1. APPLICATION TO ALTER THE SOMERSET HOUSE, 352 SOMERSET STREET WEST, A PROPERTY DESIGNATED UNDER PART V OF THE *ONTARIO HERITAGE ACT* AND LOCATED IN THE CENTRETOWN HERITAGE CONSERVATION DISTRICT

1. Manager's report, Right of Way, Heritage and Urban Design Services, Planning, Infrastructure and Economic Development Department dated 28 March 2017 (ACS2017-PIE-RHU-0003)

**Built Heritage Sub-Committee / Sous-comité du patrimoine bâti
April 13, 2017 / 13 avril 2017**

SUBJECT: Application to Alter the Somerset House, 352 Somerset Street West, a property designated under Part V of the *Ontario Heritage Act* and located in the Centretown Heritage Conservation District

Document 6 – Restoration Details

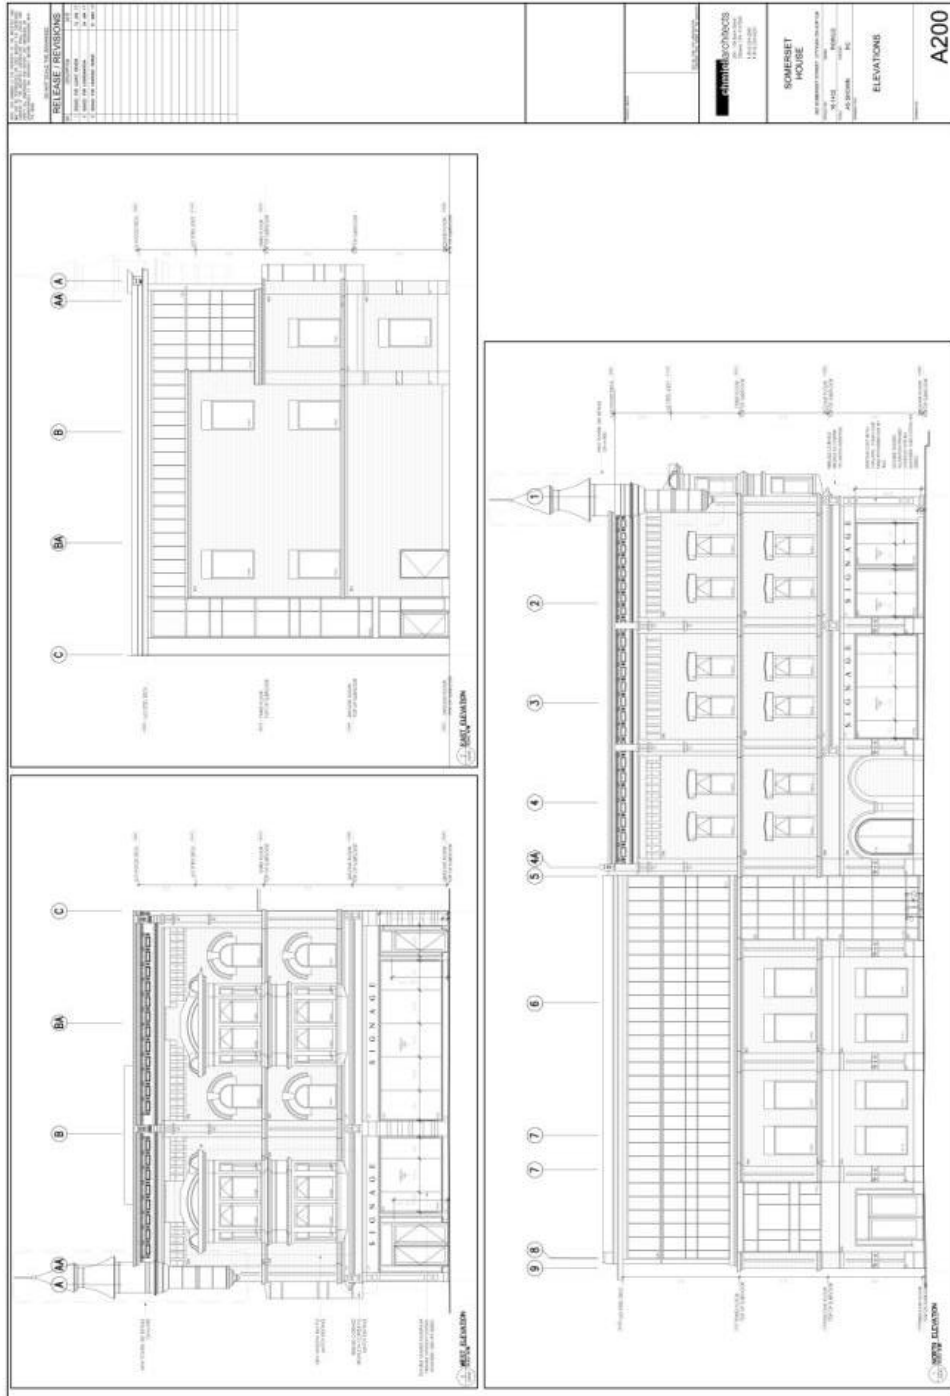
Cornice Dentils & Modillions to be Removed, Restored & Reinstated

Cornice Brackets

New Bay Window to be Constructed to Match Adjacent Existing Bay Window

Existing Turret to be Restored, Similar to Original Detailing

Precast Stone Window Headers to be Restored

Low Level Cornice to be Replicated

Arched Window Metal Work Details to be Restored

Bay Window Metal Work Relief Details to be Restored

Existing Bay Window Structure to be Reconstructed
